Application RM24.184 by Oceana  
Gold (New Zealand) Limited for  
various consents relating to the  
Macraes Phase Four mine expansion

**EVIDENCE OF**

**JOHN GRAHAM ISELI**

Figure 3-4. IM and Frasers Pit sensitive receptors

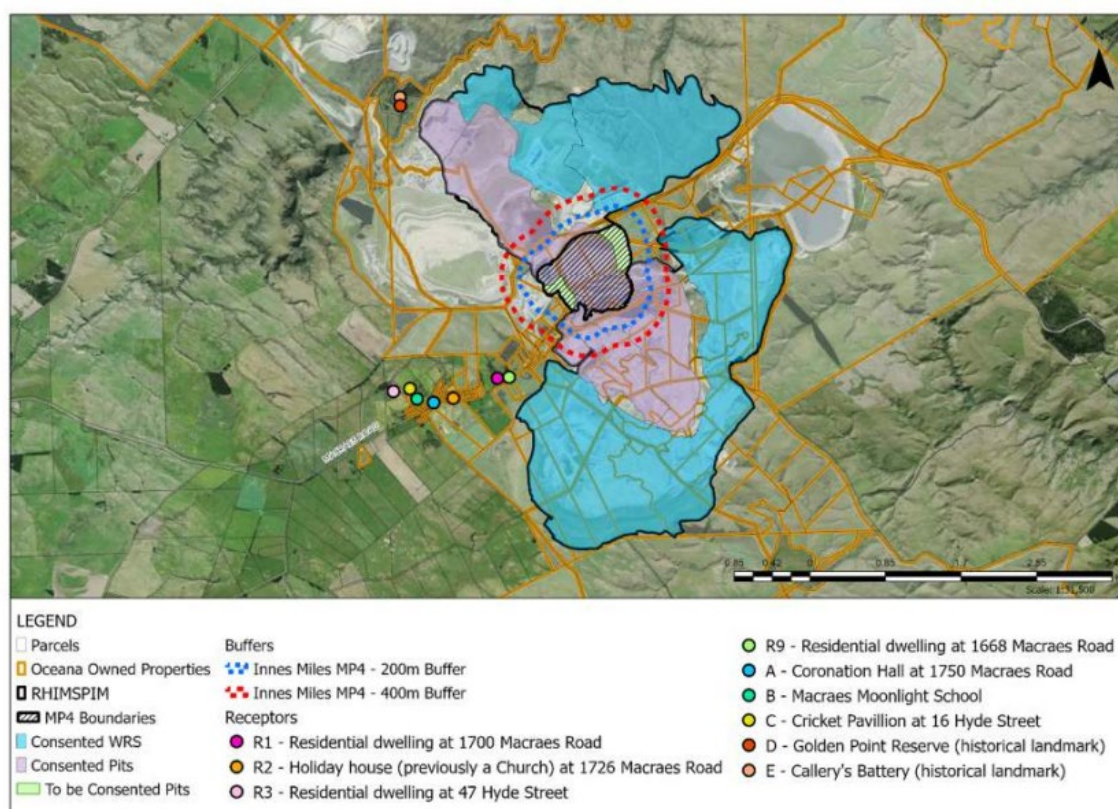
- 7.6 The location of receptors in the Macraes village area is shown in the image below, taken from the Beca AEE. Note that Receptor R9 (shed) is no longer classified as a sensitive receptor and the correct address for R1 has been confirmed by Beca as 1668 Macraes Road.

Figure 6-2. Sites DG03 and DG15 windroses (hourly averages) from 1 January 2018 – 31 December 2022 (Met data provided by OGNZL).

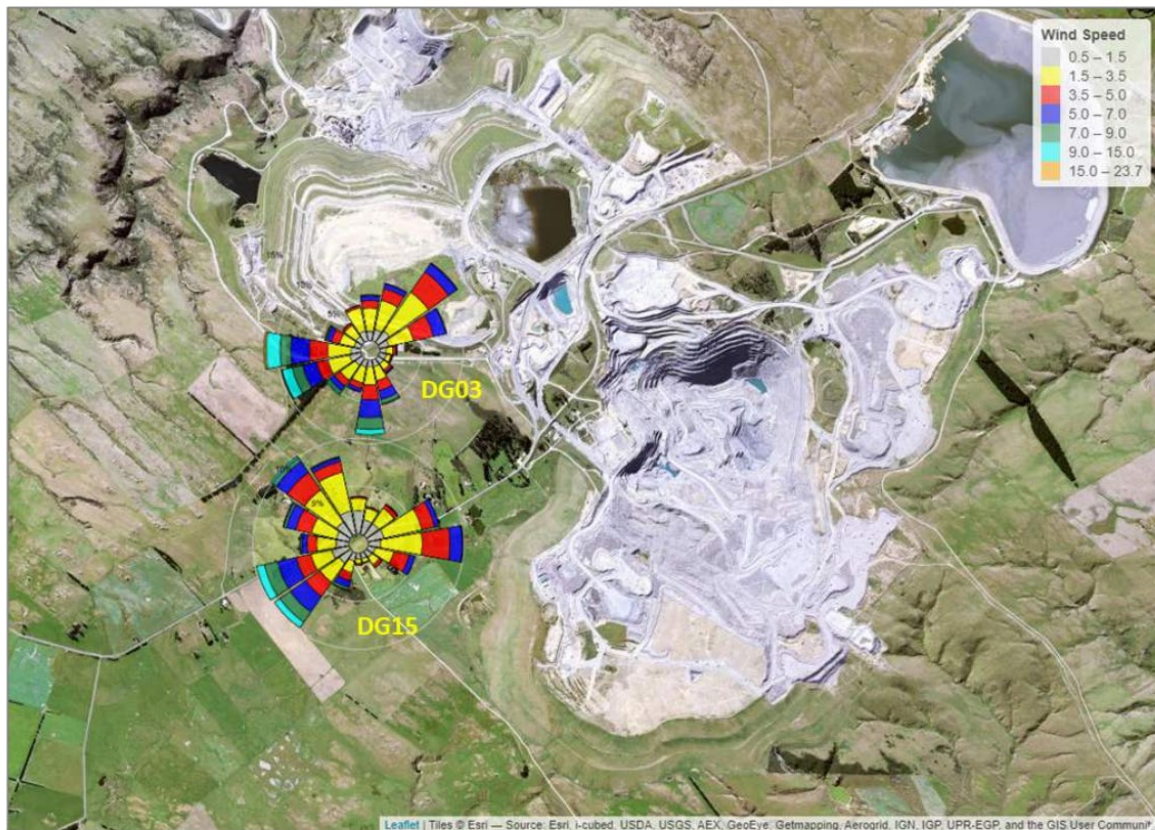
- 8.1 Meteorological monitoring occurs at sites DG03 and DG15 close to Macraes village. Beca has provided wind roses of the recorded data for 2018 to 2022, shown in the image reproduced below. The wind roses indicate that prevailing winds are from the southwest, northwest and northeast quarters. The strongest winds blow from the northwest and southwest quarters.

Figure 6-3. Sites DG03 and DG15 wind roses (hourly averages) of wind speeds >5m/s from 1 January 2018 – 31 December 2022(Met data provided by OGNZL).

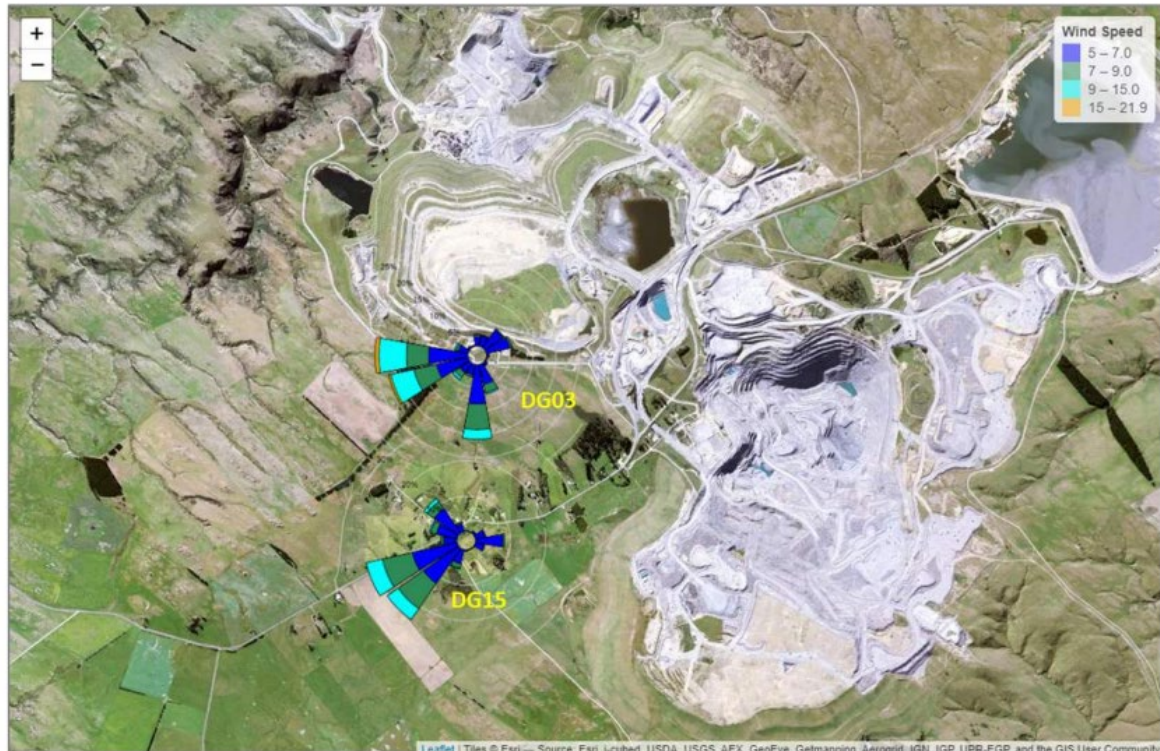
- 8.2 The analysis of local wind conditions indicates that light to moderate strength winds from the eastern quarter are common. These winds will blow from the large area of central mining activity (Fraser's and Innes Mills) towards Receptor R1 and the village for approximately 31% of the time, based on the DG15 (Macraes village) data.
- 8.3 Beca states that winds have greatest potential to transport dust at speeds greater than 5m/s. Based on the DG15 wind data, winds blowing from the central mining area towards R1 and the village occur for approximately 2.7% of the time. The figure below, reproduced from the Beca AEE, shows the wind roses when only wind speeds greater than 5m/s are included.

- 8.4 I agree with Beca that wind speeds of greater than 5m/s have the greatest potential to transport dust for significant distances, particularly in relation to entrainment of dust from the large areas of exposed surfaces involved. However, I note that some activities undertaken will generate relatively fine particulate matter with potential to be transported significant distances, even at lower wind speeds, when dry conditions prevail. In relation to this application, the haul road serving the Innes Mills and Frasers pits is a potentially significant dust source that can generate finer particles subject to transport for substantial distances, even at lower wind speeds, if appropriate mitigation is not applied.
